**From:** Davis, Michael J  
**Sent:** Wednesday, August 26, 2020 8:34 AM  
**To:** myersremodelingco@yahoo.com  
**Cc:** Oswald, Hank; Williams, Jeffrey  
**Subject:** RE: 12875 Frederick Road

**From:** Oswald, Hank  
**Sent:** Tuesday, August 25, 2020 11:00 AM  
**To:** Myers Remodeling Co.  
**Cc:** Williams, Jeffrey  
**Subject:** RE: B20001447 / 12875 Fredrick Rd / Variance for Well Setback

APPLICATION FOR VARIANCE TO COMAR ONSITE WATER/SEWER FOR MDE APPROVAL

**From:** Oswald, Hank  
**Sent:** Thursday, July 9, 2020 10:22 AM  
**To:** 'myersremodelingco@yahoo.com'  
**Cc:** Williams, Jeffrey  
**Subject:** B20001447\_12875 Frederick Road\_New FPs and Site Plan plus Variance Request Application

FOR PERCOLATION TESTING AND SITE EVALUATION

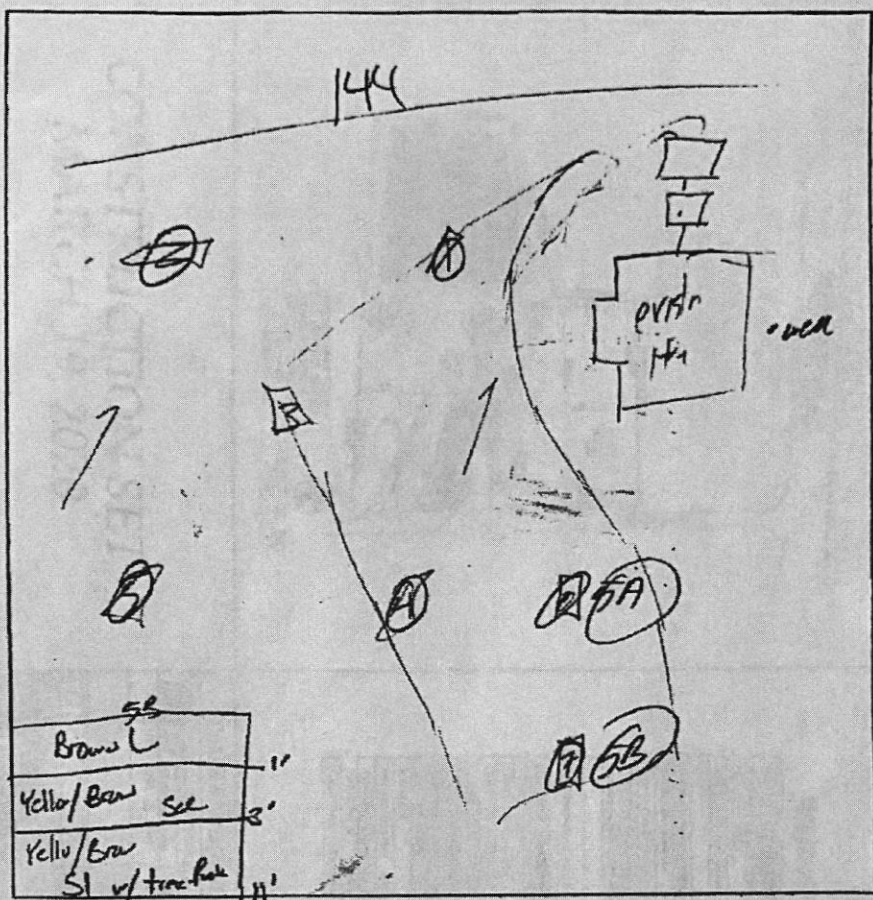
Test holes at the bottom of SDA have a 1.2 rate with 3 foot of sidewall (inlet at 3.5, bottom at 7.5 ft.). Existing length of trench is 168 ft. (w=2). If my math is correct, they are 10.4% shy of having enough trench for 5 bedrooms. Given they've already had a repair, should we restrict them to 4 bedrooms?

168 linear feet x 2' wide = 336 sq ft divided by 0.44 for sidewall credit (2+2/3+6) = 763 x 1.2 rate = 916 gallons per day allowed for that system.
